# STRUCTURAL ASSESSMENT

UCSB BUILDING #406

January 6, 2017

Re: Building #406 Structural Damage Assessment

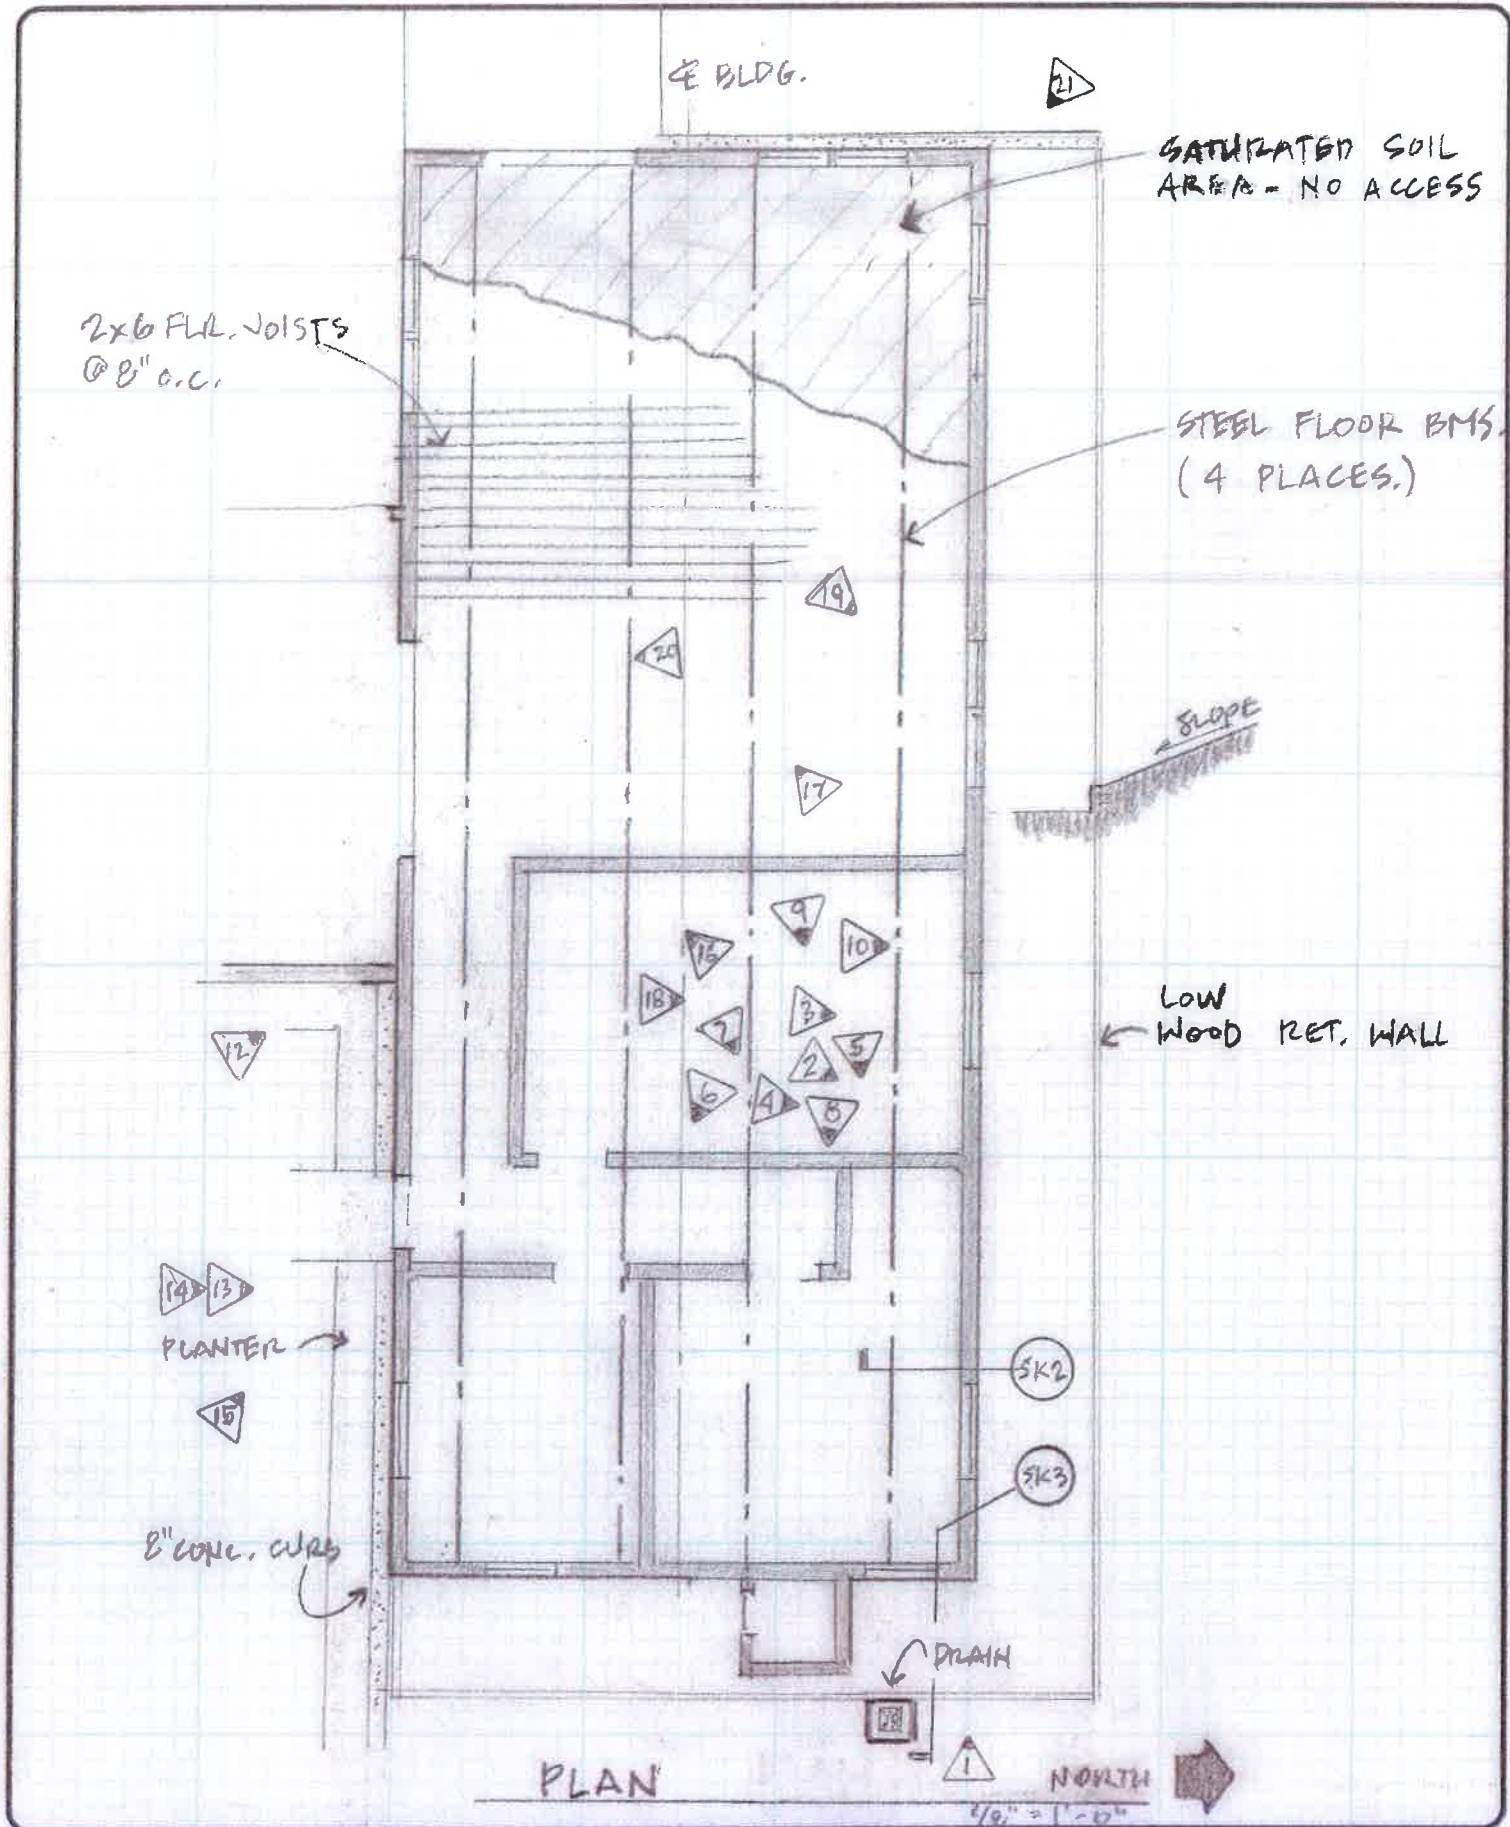
Conventional wood floor joists are supported over a shallow crawl space by steel floor beams which are supported by steel tripods resting on what appears to be small concrete or wood load distribution plate set on top of the soil sub-grade. The floor joists cantilever over the steel beams to pick up exterior wood stud walls which carry roof loads, as shown in photos #2 thru #6 and detail sketch SK-2. The roof is assumed to be conventional wood roof joist construction supporting plywood sheathing.

Currently, no structural foundation system exists to prevent the building's collapse in the event of a significant seismic event (Reference detail sketch SK-2). The building would simply shift laterally, either tipping over all the rusted metal tripod supports, or simply sliding of the top of these supports due to the lack of a proper connection. Such a motion and impact of the frail wood building on the ground below could be enough to distort and collapse the walls and roof above with potentially tragic consequences.

CROSS-SECTION SHOWING RELATIONSHIP  
OF DRAIN INLET TO CRAWL SPACE & FIN. FLR.

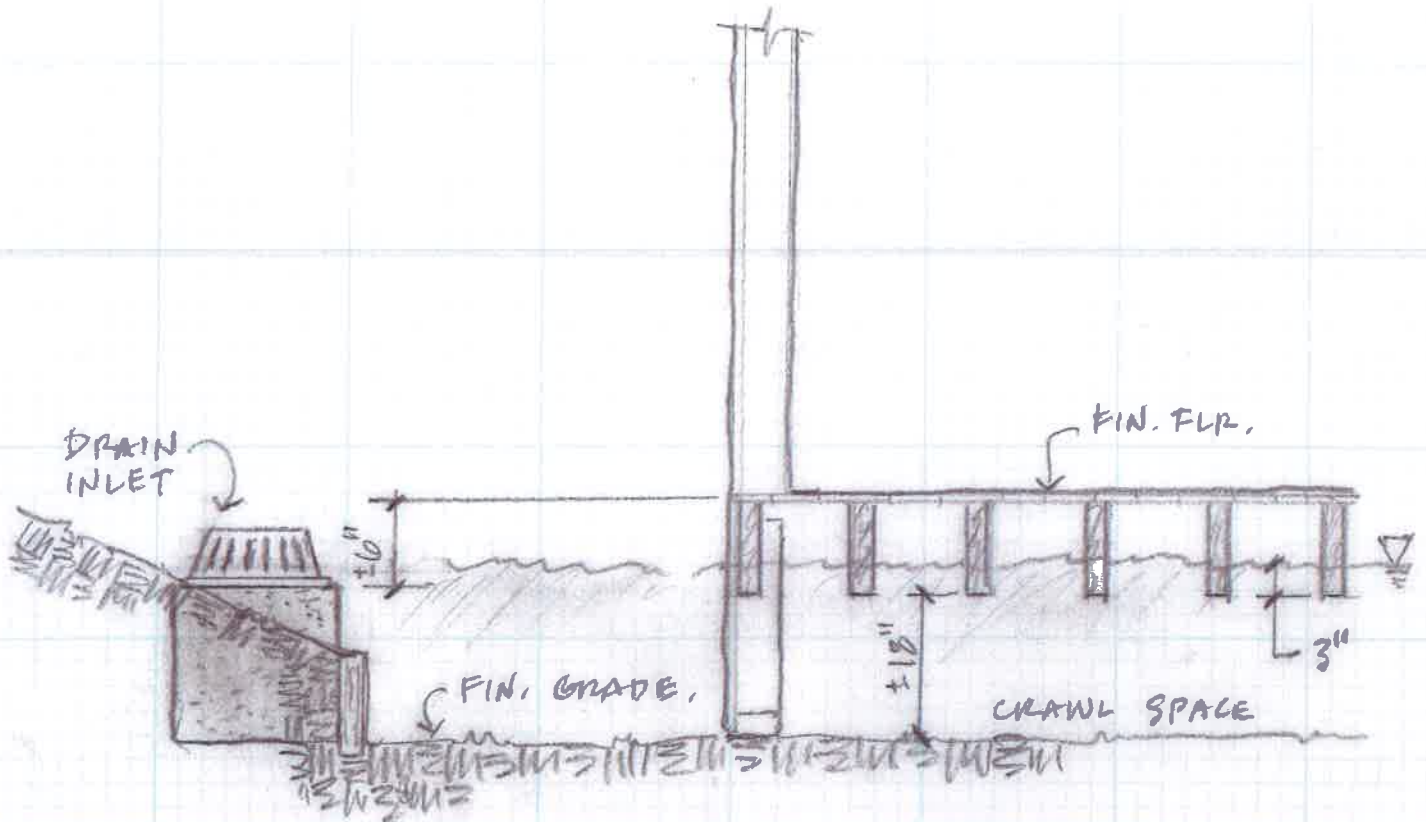
Not only are the metal tripods that support the building resting on a wood block on top of the soil, but the under-floor soil grade is not higher than the exterior soil grade which allows water intrusion into the crawl space (Reference detail sketch SK-3). The resulting saturated condition (mud) greatly reduces the capacity of the soil to support the weight of the building in addition to creating a moist environment which promotes mold, dryrot and insect infestation. The crawl space is not drained or adequately ventilated causing serious structural damage and increased risk of collapse, in addition to health risks to inhabitants where mold growth is encouraged.

PHOTO 17

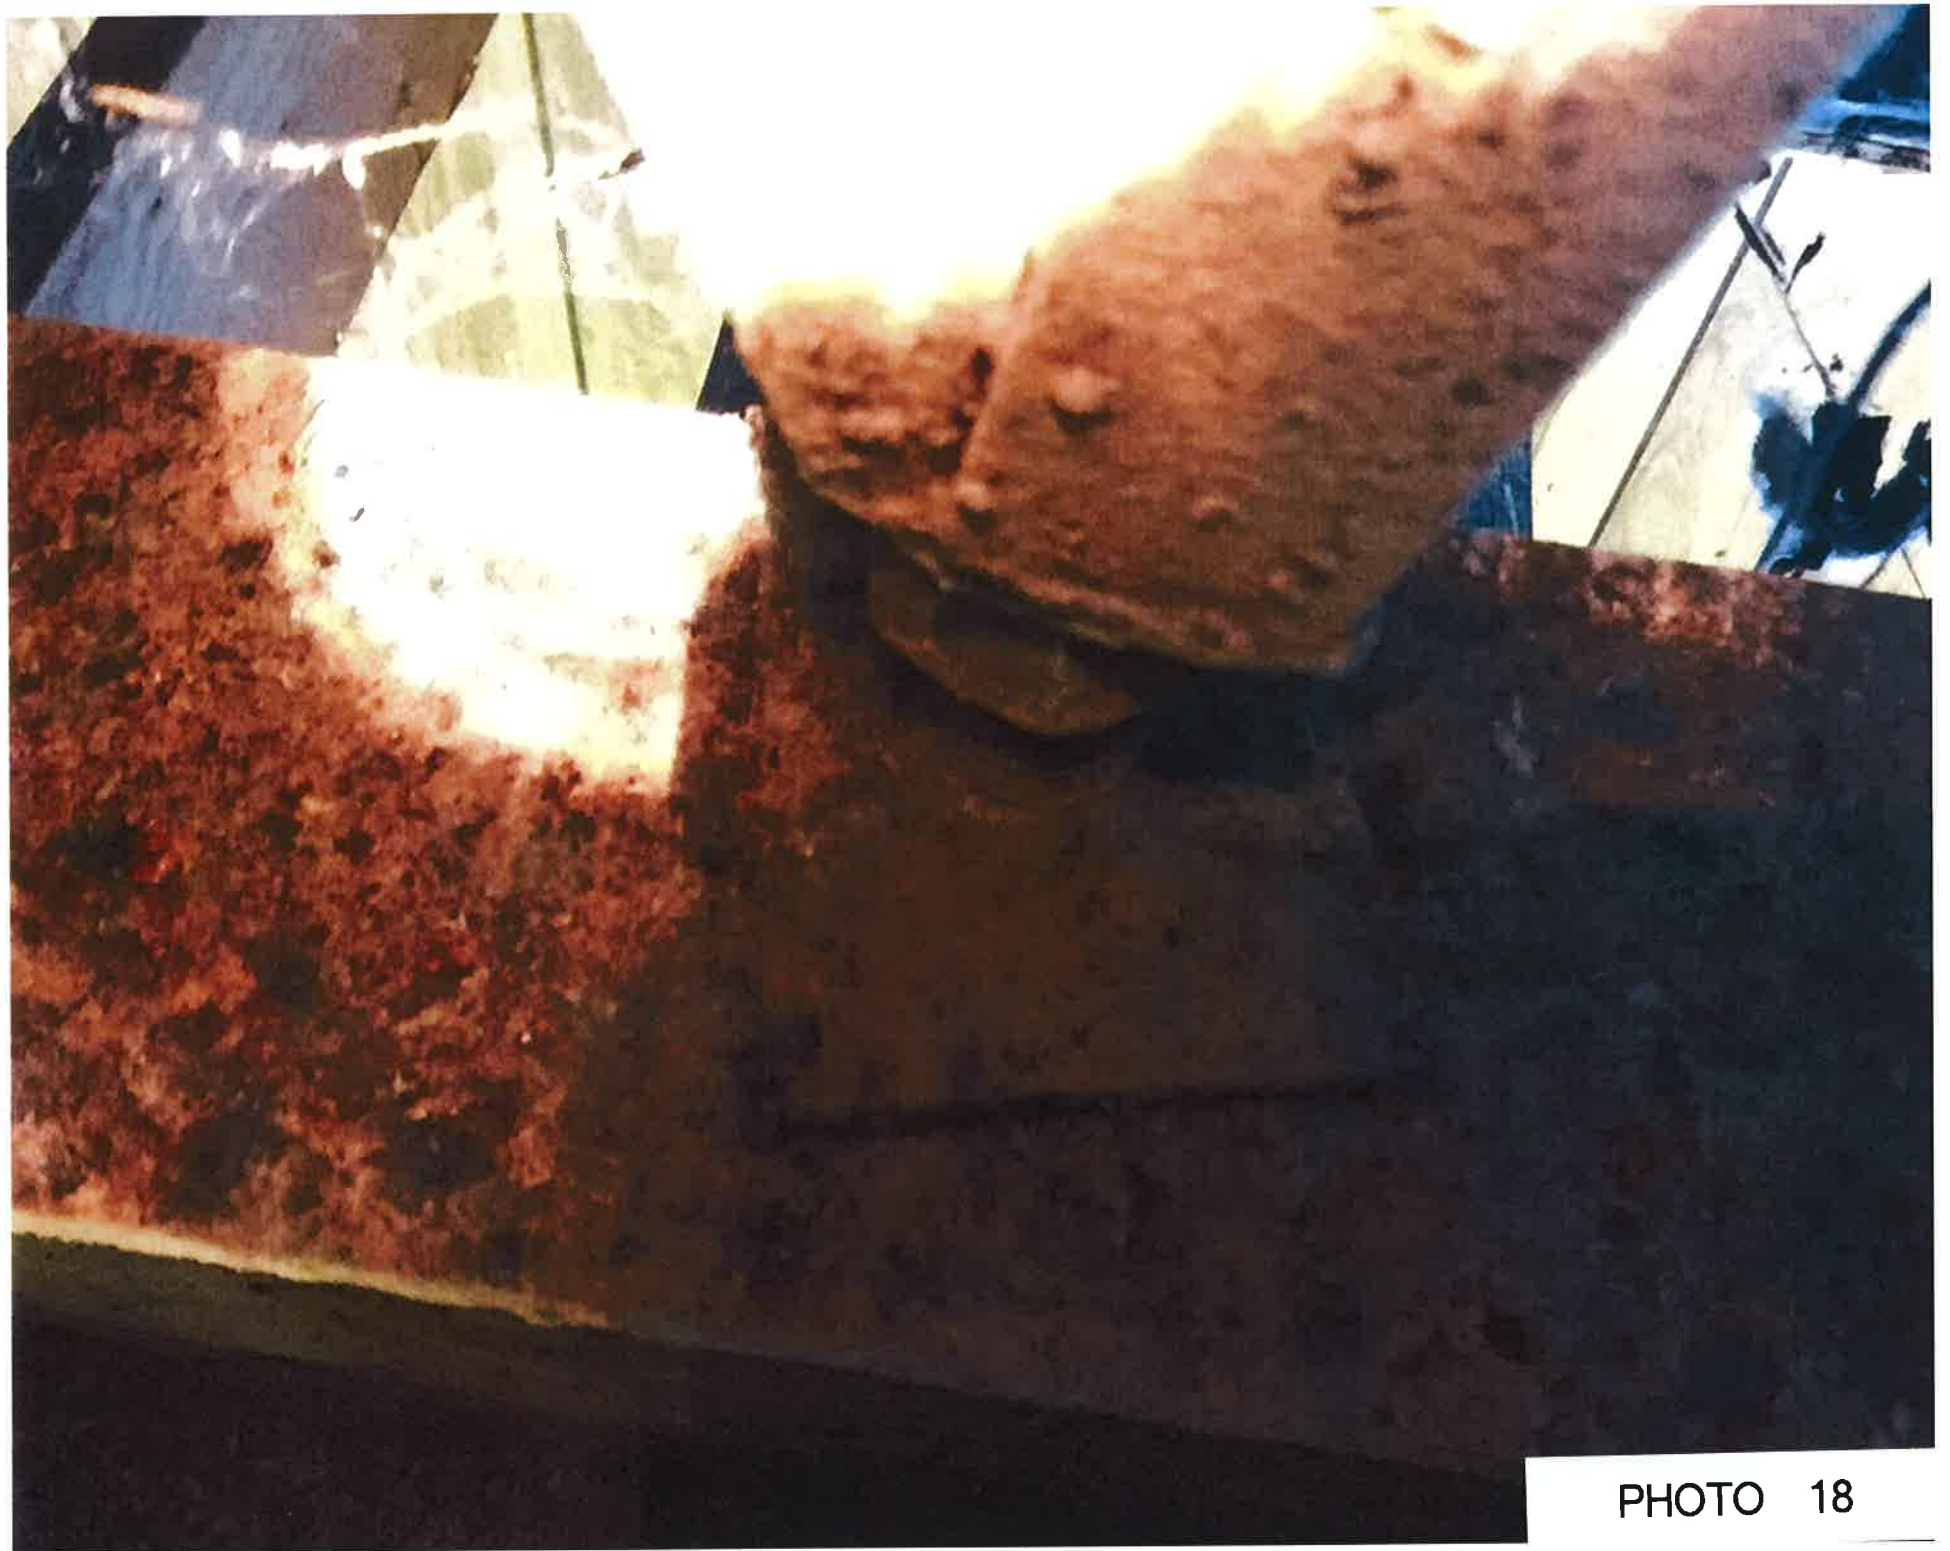
The rusted metal tripods (photos #16 thru #19) supporting the main steel floor beams are not connected to the beams and are also not connected to a reliable pad foundation.
